# Wisconsin Department of Transportation

**Proposal #21: 1517-07-80, WISC 2016 481  
 USH 10 – USH 10/STH 441  
 County CB – Oneida Street  
 USH 10  
 I-41 Interchange Ramps  
 Winnebago County**

**Letting of December 13, 2016**

This is Addendum No. 01, which provides for the following:

PROJECT NO: 1517-07-80	COUNTY: WINNEBAGO	ITS - USH 10	SHEET 161
FILE NAME : \\S15102K306\projects\Transpor\T\US 10 MIS 441\CADD\Sheets\15170780\021409-fm.dgn	HWY: USH 10	PLOT BY : Jess.Loc.Lonelle	WSDOT/CADD SHEET 42
		PLOT DATE : 11/10/2016	PLOT SCALE : 100.0000 sf / in.

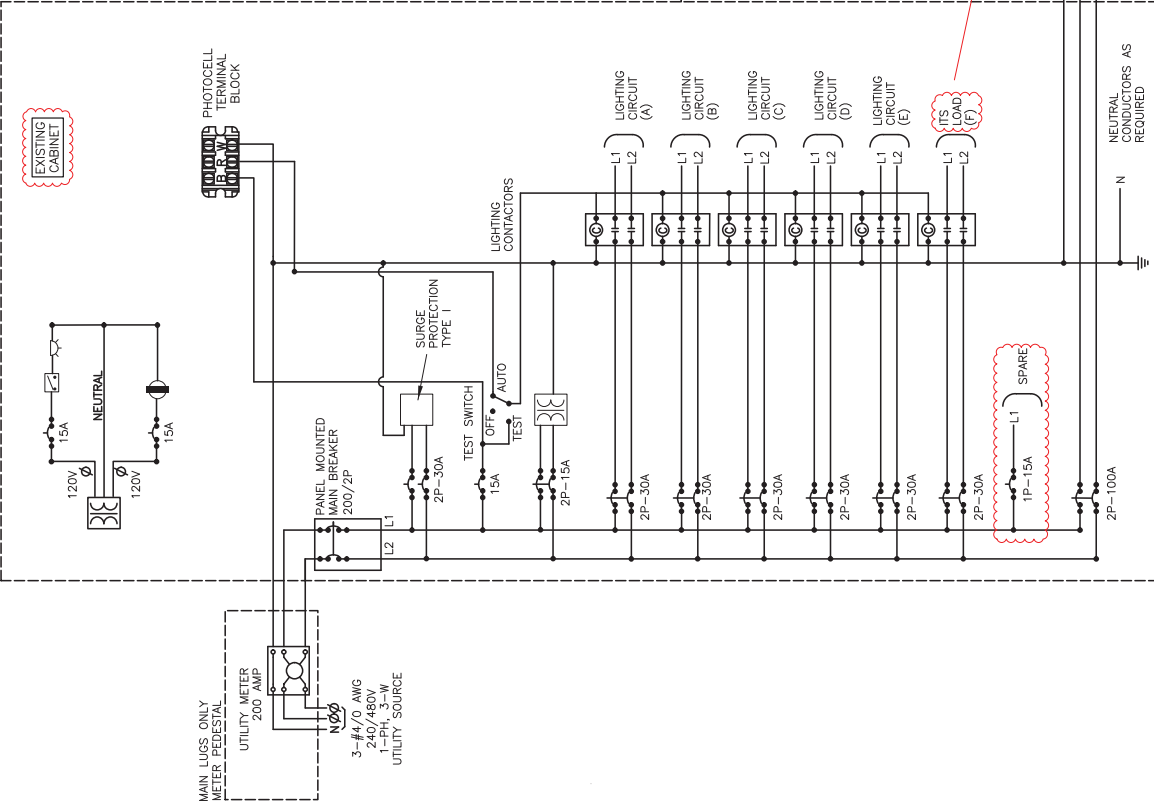
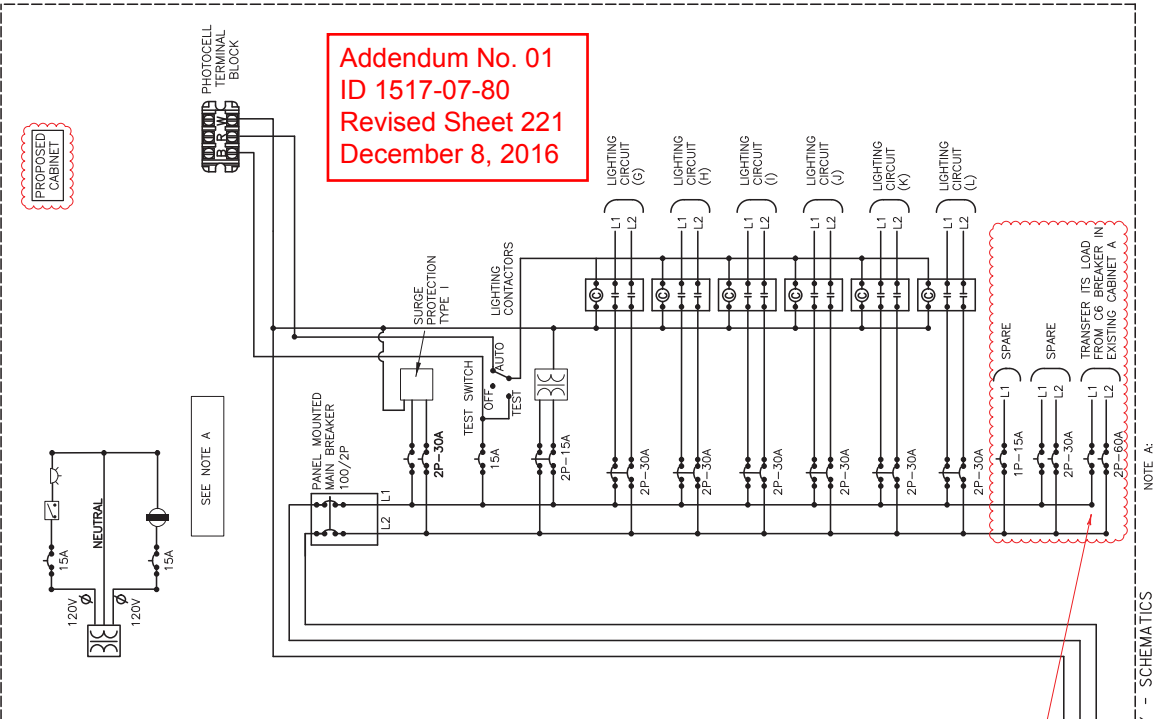
Revised Plan Sheets	
Plan Sheet	Plan Sheet Title (brief description of changes to sheet)
161	ITS-USH 10 (moved some 07-76 work to 07-80)
221	Lighting- Construction Details – Control Cabinet Schematics (revised circuit diagram)
226	Lighting Plan Overview (revised 'WisDOT Systems' information)
241	Lighting Plan – USH 10/441 System Interchange (revised control cabinet callouts)
242	Lighting Plan – Wiring Schematic (revised control cabinet callouts)
413	Miscellaneous Quantities (revised 'temporary barrier' quantities)
417	Miscellaneous Quantities (removed 'removing rumble strips' quantity)
418	Miscellaneous Quantities (moved some 07-76 lighting work to 07-80)

Addendum No. 01  
 ID 1517-07-80  
 Revised Sheet 161  
 December 8, 2016

NO SCALE  
SHEET 2 OF 2  
LIGHTING CONTROL CABINET - FREEWAY - SCHEMATICS

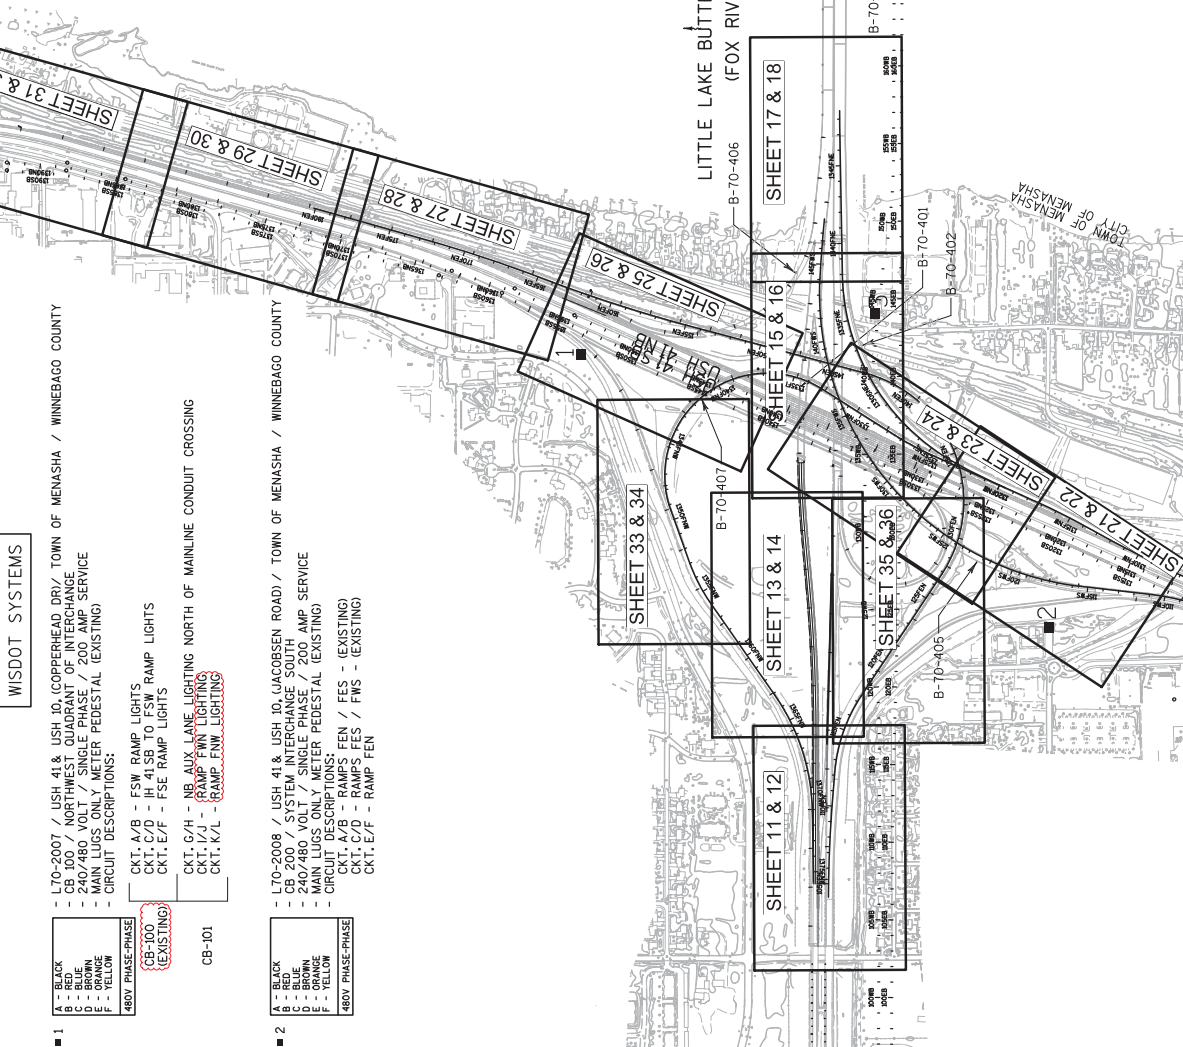
Addendum No. 01  
ID 1517-07-80  
Revised Sheet 221  
December 8, 2016

NOTE A:  
PROVIDE LABEL ABOVE 100 AMP MAIN BREAKER THAT SAYS:  
THIS PANEL IS SUB-FED FROM NEIGHBORING CABINET

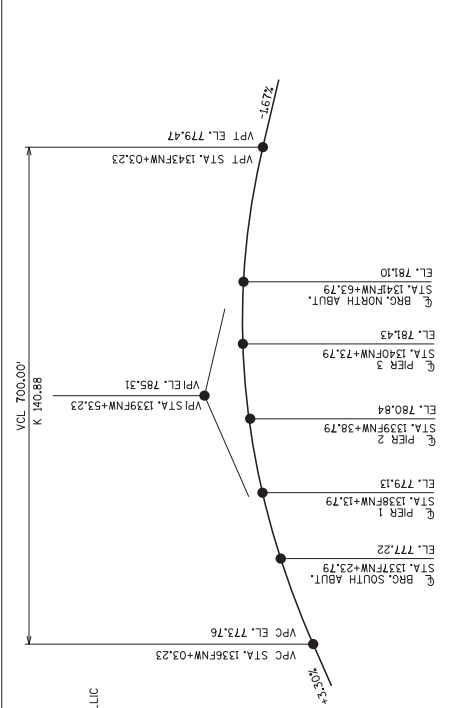
427	Miscellaneous Quantities (moved some 07-76 ITS work to 07-80)
428	Miscellaneous Quantities (moved some 07-76 ITS work to 07-80)
642	B-70-407, General Plan and Elevation (Updated temporary shoring and slope paving callouts)
643	B-70-407, Cross-Section (Updated typical section)
644	B-70-407, General Notes and Quantities (Updated quantities)
646	B-70-407, South Abutment Details (1 of 5) (Updated pile note and dimensions)
647	B-70-407, South Abutment Details (2 of 5) (Updated notes and dimensions)
648	B-70-407, South Abutment Details (3 of 5) (Updated callouts and rebar)
649	B-70-407, South Abutment Details (4 of 5) (Updated dimensions and rebar)
650	B-70-407, South Abutment Details (5 of 5) (Updated rebar)
651	B-70-407, South Abutment Approach Slab (Updated notes and callouts)
652	B-70-407, North Abutment Details (1 of 4) (Added pile note)
653	B-70-407, North Abutment Details (2 of 4) (Updated callouts and rebar)

**Addendum No. 01**  
**ID 1517-07-80**  
**Revised Sheet 642**  
**December 8, 2016**

NO.	DATE	REVISION	BY
10/12/16		REVISED CALLOUTS/TEMP SHORING	DNU
<b>AECOM</b>			
1505 South Rivercenter Drive, Suite 214 Madison, WI 53704 (608) 261-4222			
STATE OF WISCONSIN DEPARTMENT OF TRANSPORTATION			
ACCEPTED	CHIEF STRUCTURES DESIGN ENGINEER	DATE	
<b>STRUCTURE B-70-40T</b>			
COUNTY	WINNEBAGO	TOWN/VILLAGE/TOWNSHIP	MENASHA
DESIGN SPEC.	ASHTO LRFD BRIDGE DESIGN SPECIFICATIONS	DESIGN LANE	LKH
BY	ASSIGNED JRS	BY	DNU
<b>GENERAL PLAN AND ELEVATION</b>			
			SHEET 1 OF 47
			<b>642</b>

STATE OF WISCONSIN  
DEPARTMENT OF TRANSPORTATION  
STRUCTURE B-70-407  
NORTH ABUTMENT  
DETAILS (2 OF 4)  
SHEET 12 OF 47  
653

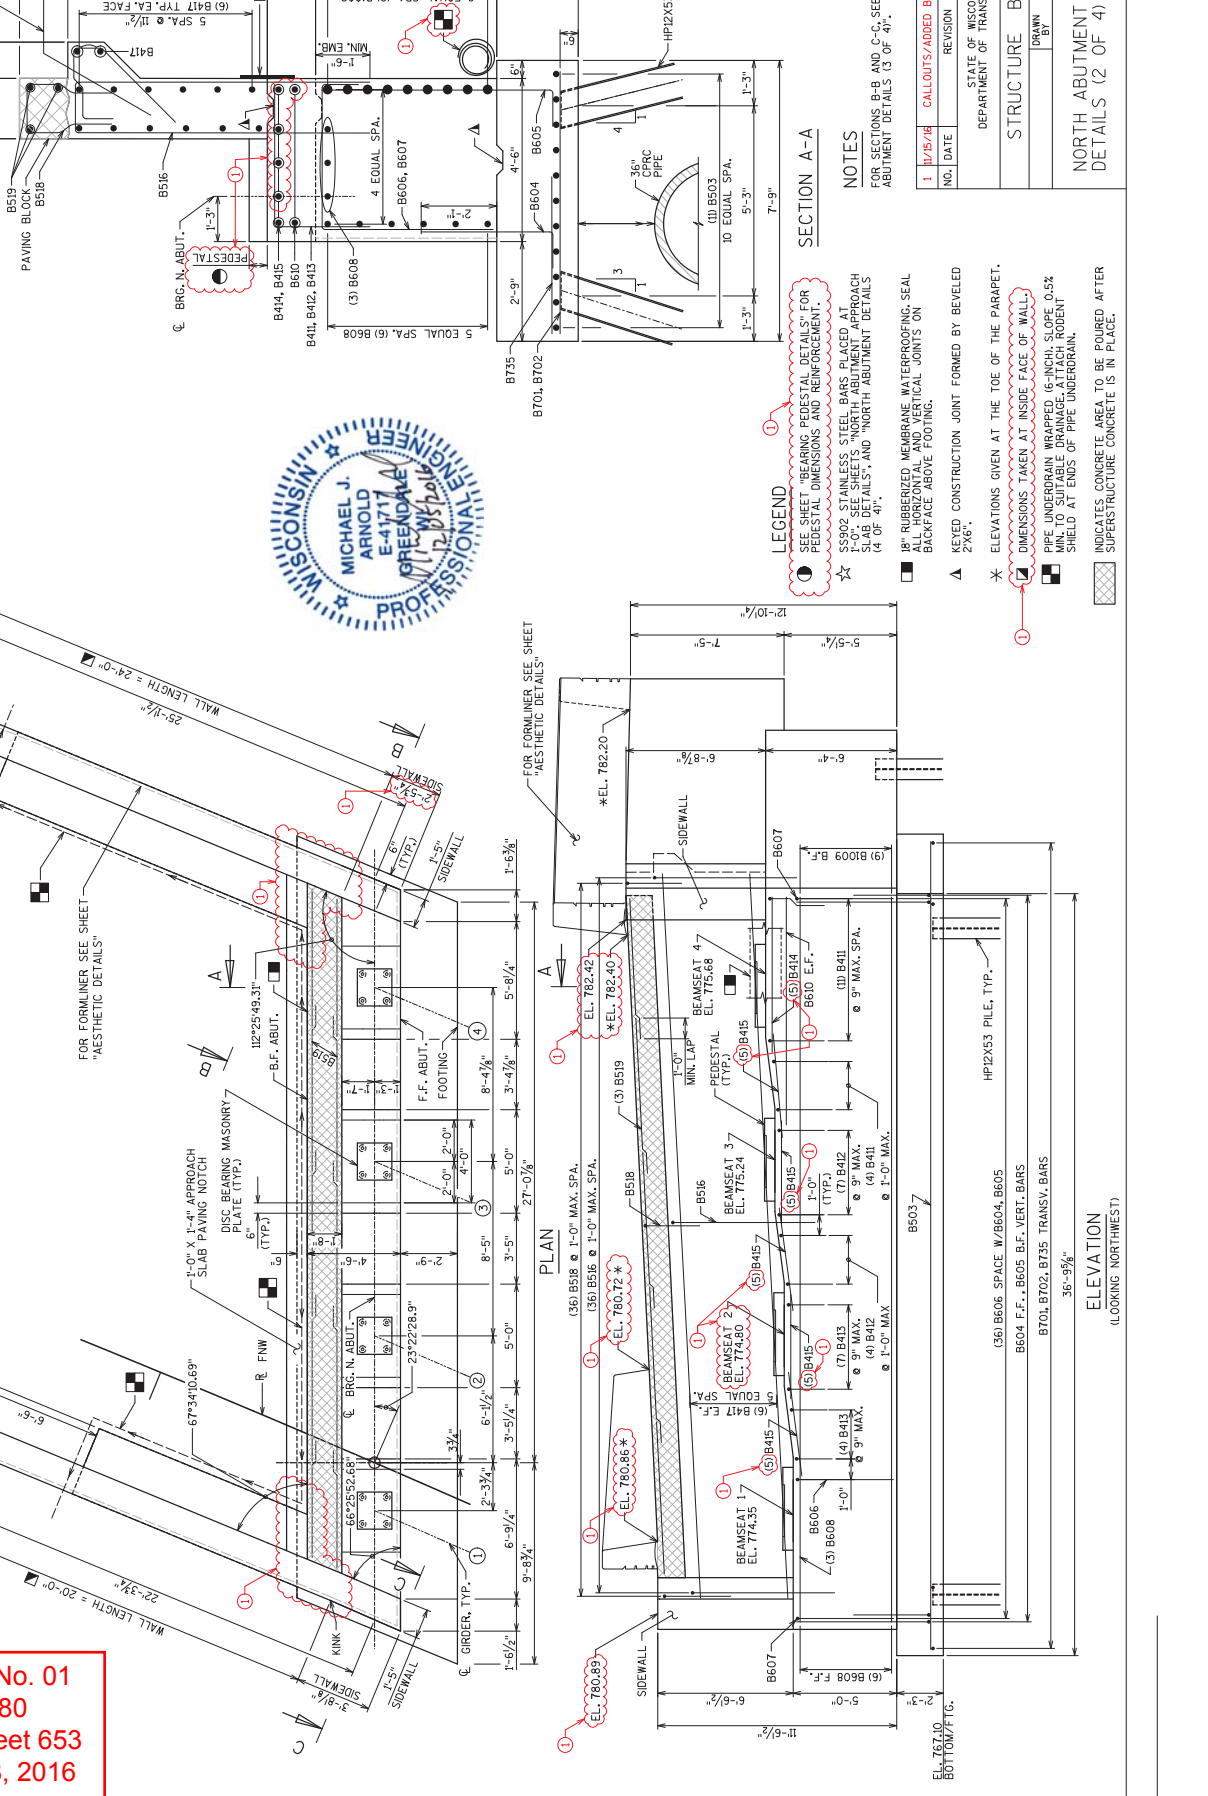
Addendum No. 01  
ID 1517-07-80  
Revised Sheet 653  
December 8, 2016

NO.	DATE	REVISION	BY
1	11/15/16	CALLOUTS/ADDED B610 BAR	DNU/JDL

1	11/15/16	REBAR / DIMENSIONS	DNU/JDL
NO.	DATE	REVISION	BY
STATE OF WISCONSIN DEPARTMENT OF TRANSPORTATION			
STRUCTURE B-70-407			
ISSUED BY: DNU/JAN			
CHECKED BY: JDL			
NORTH ABUTMENT SHEET 13 OF 47			
654

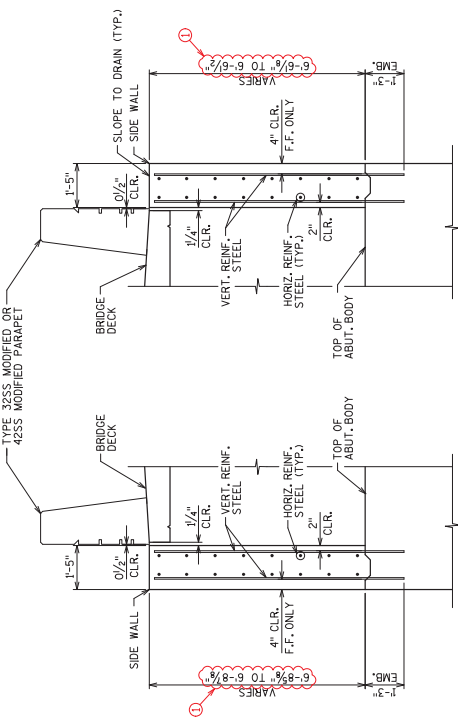
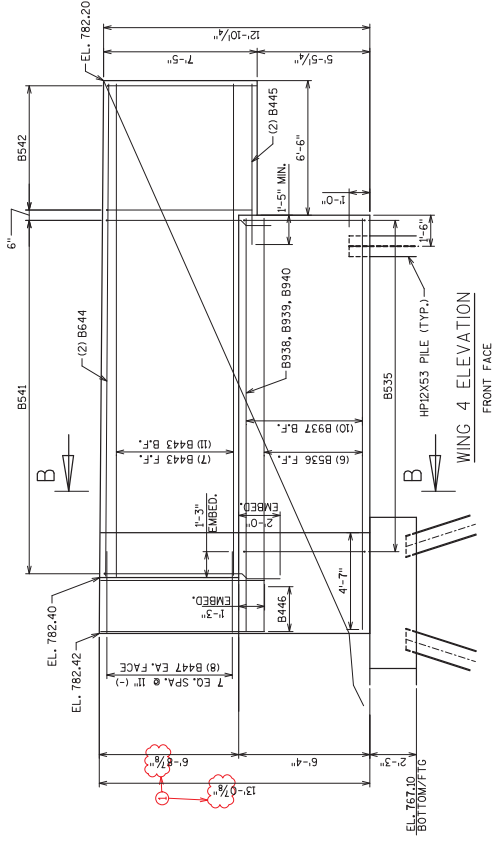
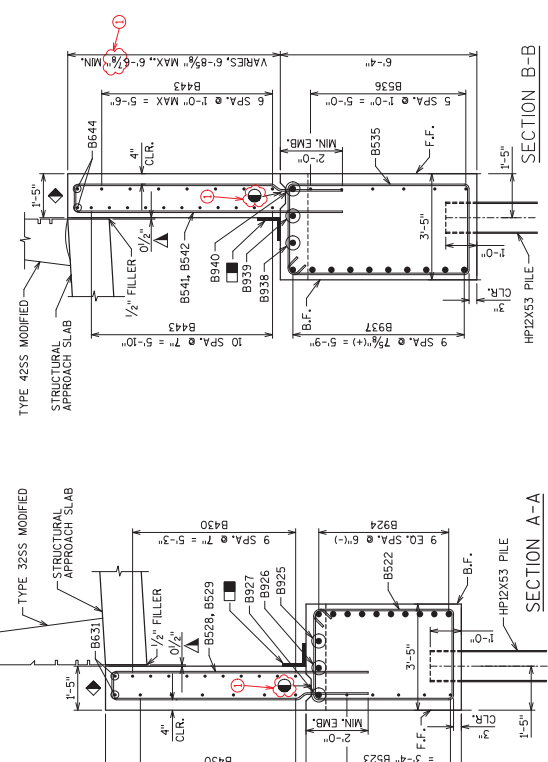
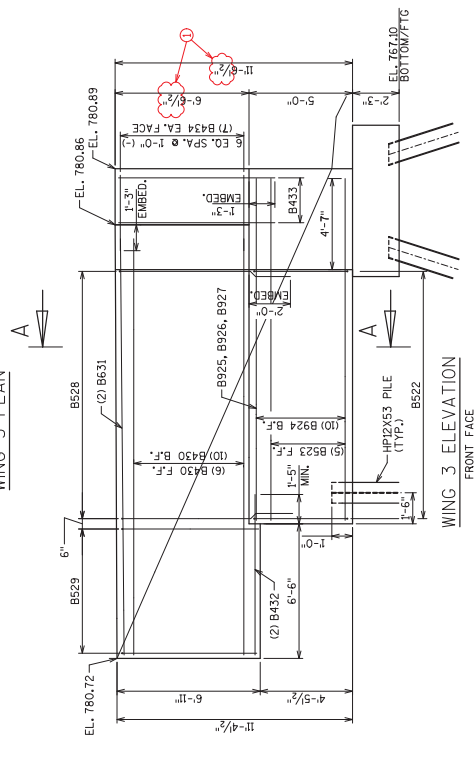
654	B-70-407, North Abutment Details (3 of 4) (Updated rebar)
655	B-70-407, North Abutment Details (4 of 4) (Updated dimensions and notes)
656	B-70-407, North Abutment Approach Slab (Update callouts and rebar)
657	B-70-407, Pier 1 Details 1 (Updated dimensions)
658	B-70-407, Pier 1 Details 2 (Updated rebar)
661	B-70-407, Pier 3 Details 1 (Updated callouts)
662	B-70-407, Pier 3 Details 2 (Updated rebar)
668	B-70-407, Girder Details (4 of 4) (Added notes)
672	B-70-407, Superstructure Plan 1 (Added reference line)
675	B-70-407, Superstructure Details (Updated rebar)
677	B-70-407, Single Slope Parapet 32SS Modified (Updated rebar and notes)
678	B-70-407, Single Slope Parapet 42SS Modified (Updated rebar and notes)
679	B-70-407, Single Slope Parapet Details (Updated dimensions)
680	B-70-407, 42SS Parapet Electrical (Added notes)
681	B-70-407, Light Standard (Updated light locations)
682	B-70-407, Strip Seal Expansion Joint Details (Added temp table)

Addendum No. 01  
 ID 1517-07-80  
 Revised Sheet 654  
 December 8, 2016

⑤ 1 11/8" B6 ADDED NOTE, UPDATED DIMENSIONS

**SECTION D-D**  
SECTION THRU APPROACH SLAB

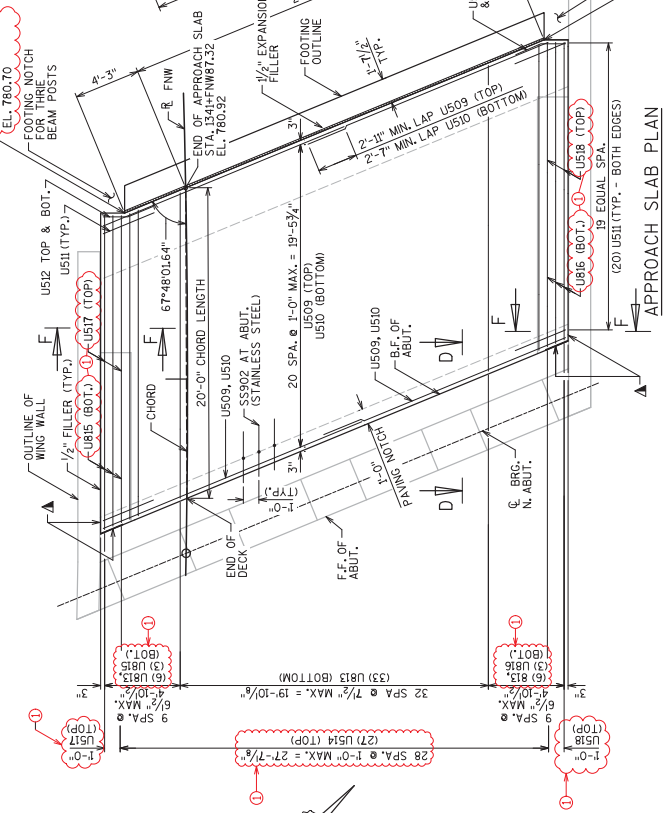
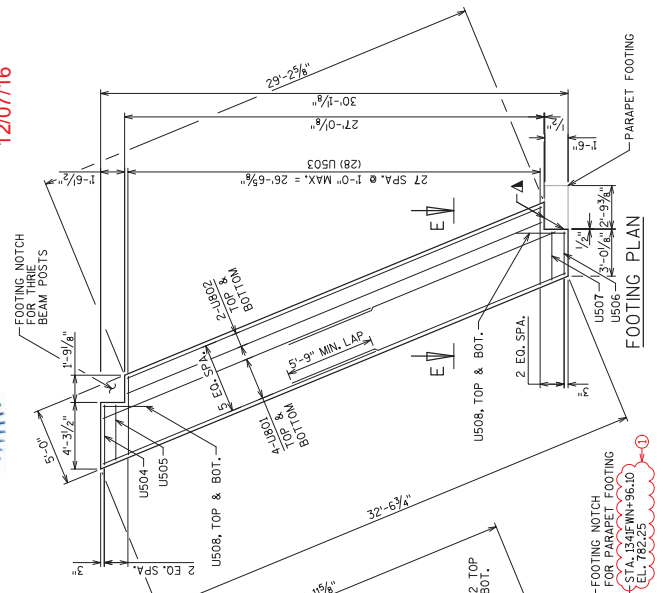
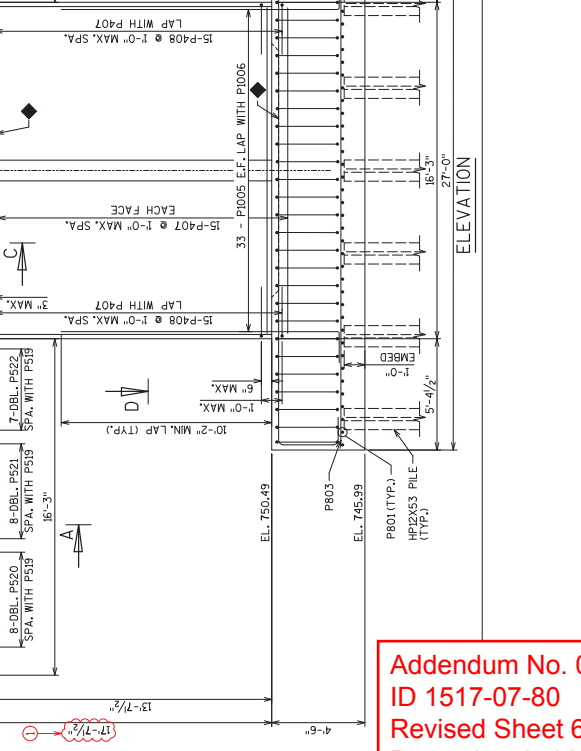
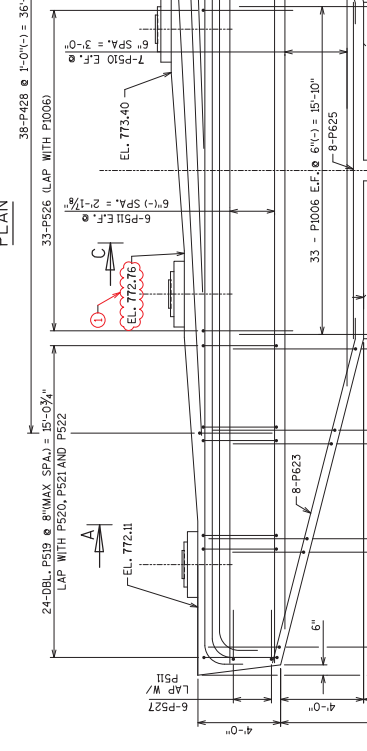
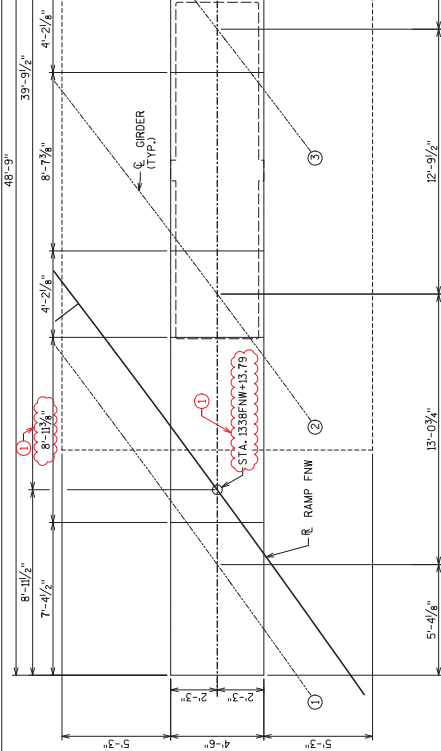
Addendum No. 01  
ID 1517-07-80  
Revised Sheet 656  
December 8, 2016
